Quick feedback on Rain Forest Parkway speed bumps

Proposed speed bumps on Rain Forest Parkway between Providence and Range Line.pdf
1085K

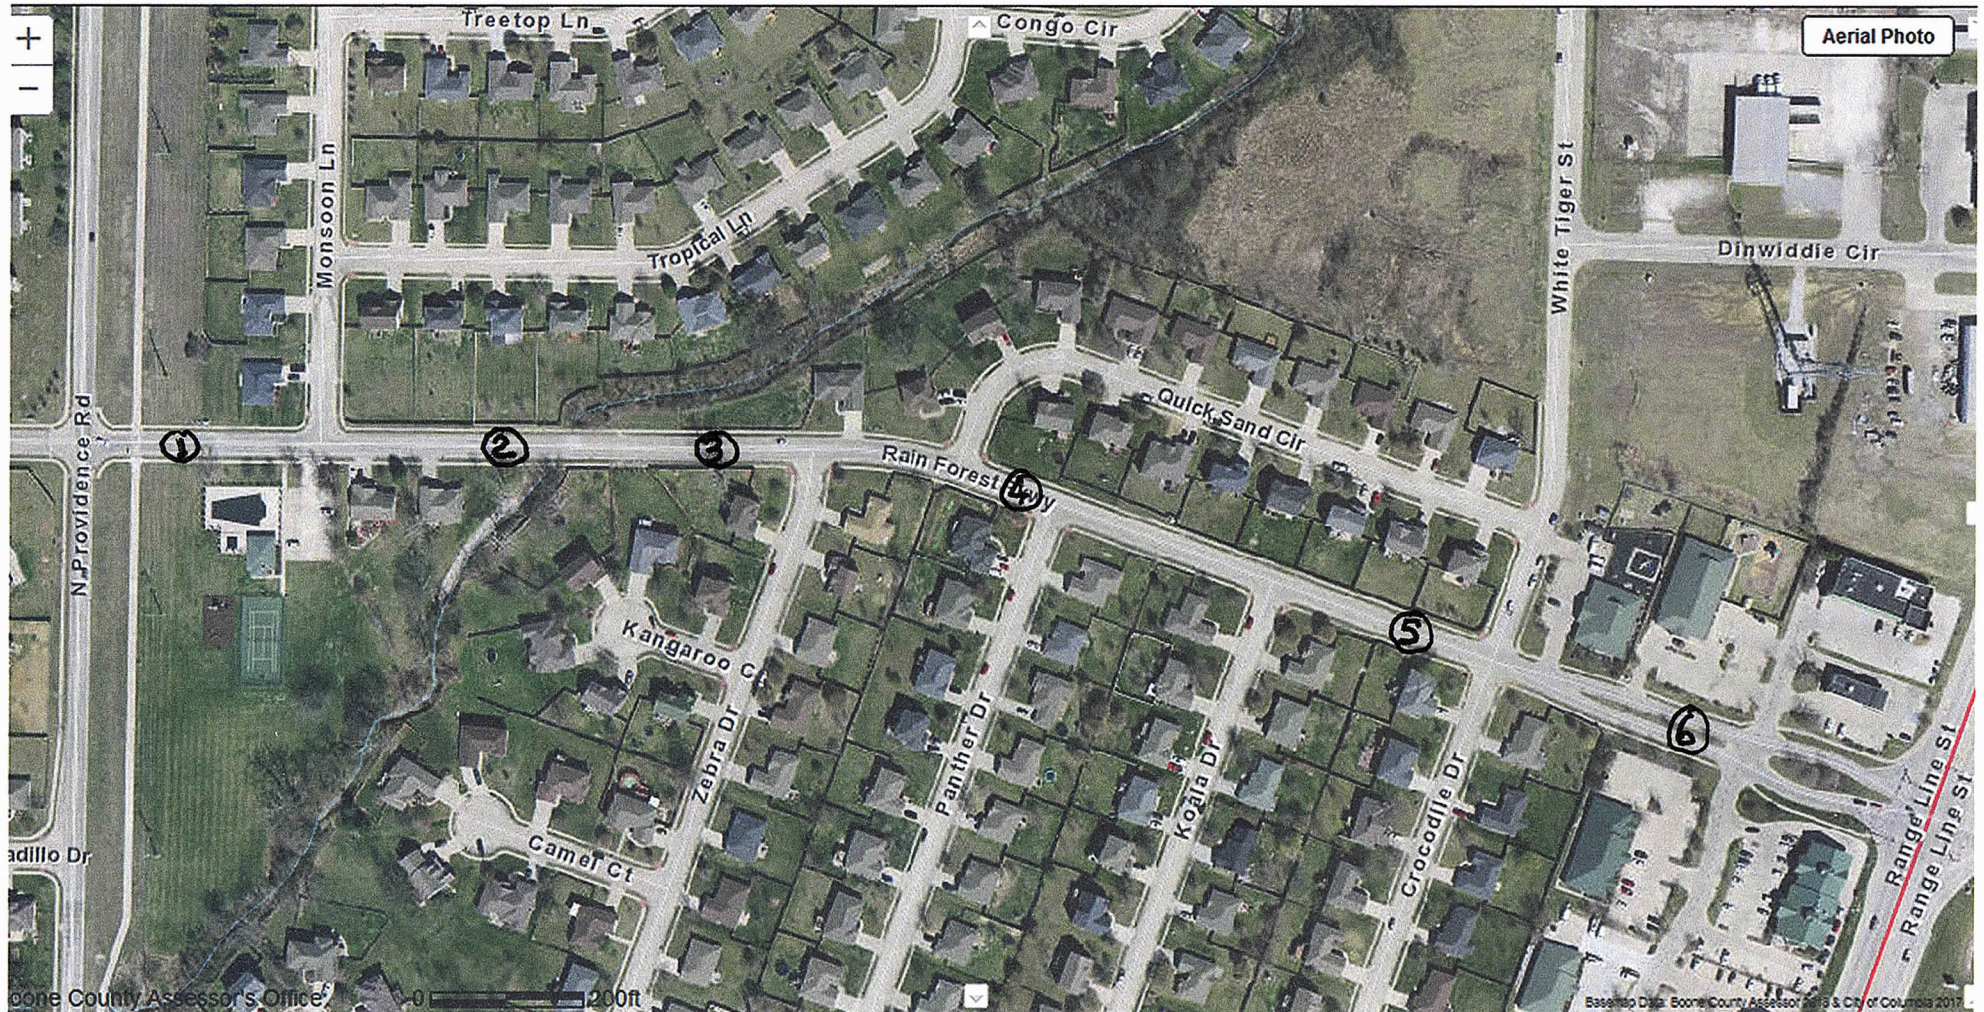
- ① NEW 25mph SPEED BUMP SLOWS TRAFFIC AT EASTBOUND ENTRY
- ② EXISTING 25mph SPEED BUMP
- ③ EXISTING MEDIAN
- ④ PROPOSED 25 MPH SPEED BUMP SLOWS WESTBOUND TRAFFIC AT BOTTOM OF HILL
- ⑤ PROPOSED 25 MPH SPEED BUMP " " " AT RESIDENTIAL ENTRY
- ⑥ POSSIBLE 25 MPH SPEED BUMPS (1 EACH LANE) SLOW ENTRY / EXIT TRAFFIC NEAR INTERSECTIONS

AT \$4K @ BUMP, COUNTING ⑥ AS TWO BUMPS, \$20K TOTAL COST

ANOTHER BUMP BETWEEN ④ + ⑤ COULD BE ADDED LATER BUT HOPEFULLY NOT NEEDED!
